License No. 29-03047-01
Docket No. 030-02465
Control No. 111798

Beth Israel Hospital
ATTN: Jeffrey Moll
Executive Director
70 Parker Avenue
Passaic, New Jersey 07055

This is in reference to your request in a letter dated December 21, 1989 to renew License No. 29-03047-01. In order to continue our review, we need the following additional information:

FLOOR PLAN

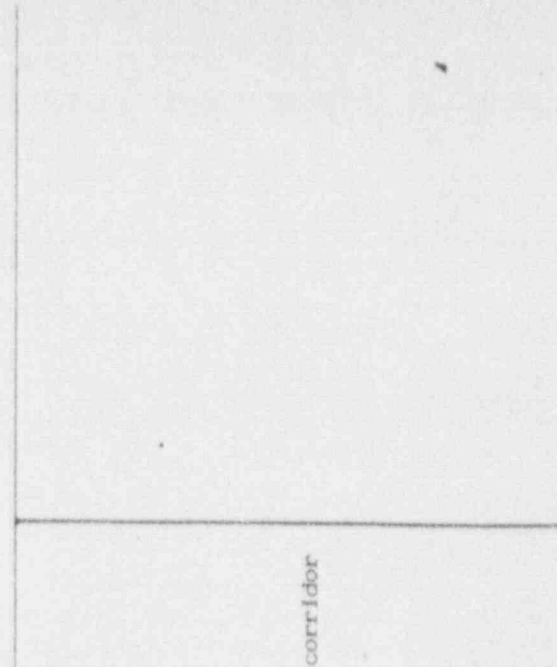
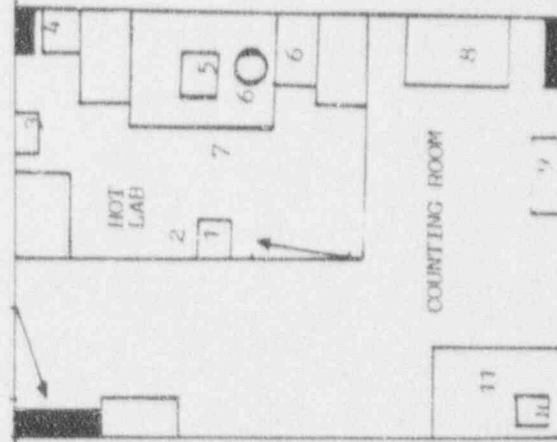
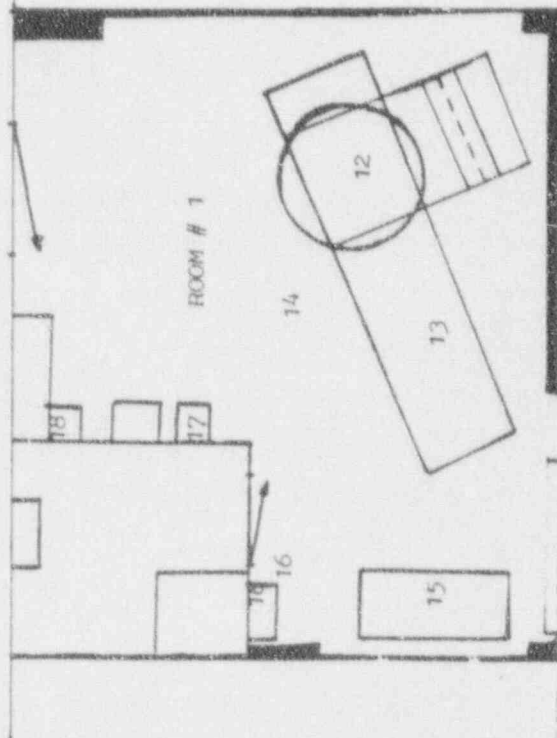
2. On a detailed version of your facility diagram, please indicate the type, dimensions, position and thickness of shielding that you will use for:
 - a. Use and storage of Tc-99m generators.

- b. Storage of radiopharmaceuticals (refrigerated and nonrefrigerated).
 - c. Storage of radioactive waste, including decay-in-storage prior to disposal as nonradioactive waste. (This area should be large enough to handle an accumulation of used Tc-99m generators as well as other solid waste. If this area is located ancillary to your department, describe how you will secure the material. Confirm that this area will be surveyed at least weekly.)

- d. Preparation and dispensing of 10 CFR 35.200 kit radiopharmaceuticals (e.g., lead glass L-block, etc.).
 - e. Identify adjacent areas across the walls from use and storage locations and show that adequate steps have been taken to assure that radiation levels in unrestricted areas do not exceed the limits specified in 10 CFR 20.103 (enclosed).

- f. Confirm that a fume hood will be available for the storage of multi-dose volatiles and gases.
